Product Change Notification

Issue Date: October 11, 2018

Product Name: PPC-F15A-H81 Series

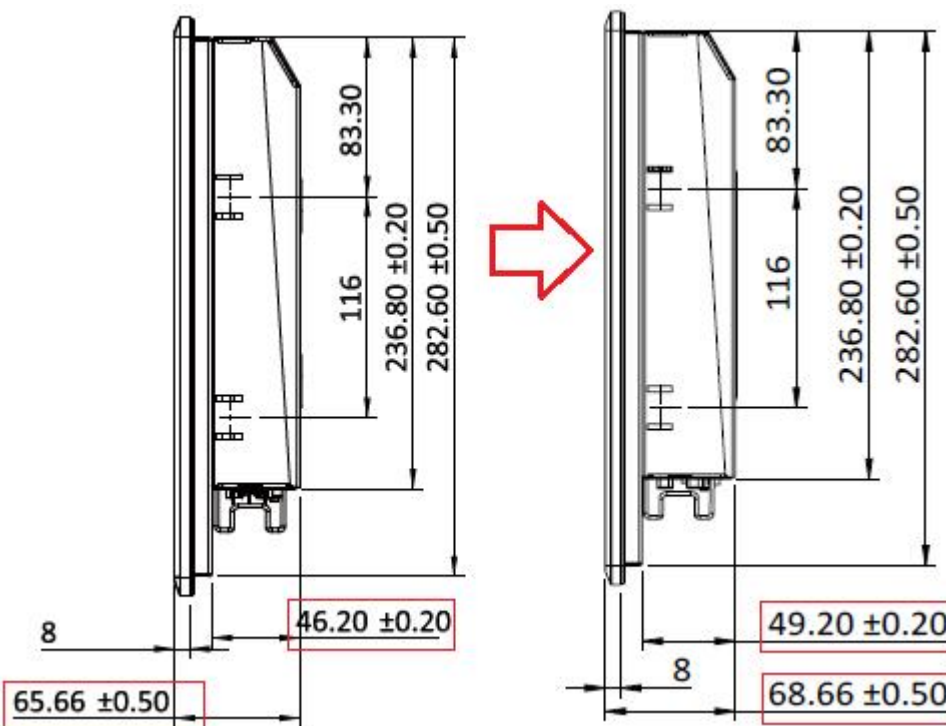
In order to enhance system performance, the CF1156D-RS CPU fan installed in the PPC-F15A-H81series is replaced with the CF-115XD-R10 cooling module. Due to this change, the mechanical dimension of the PPC-F15A-H81series is slightly modified to accommodate the new cooling module.

Change the depth dimension from 65.7mm to 68.7mm.
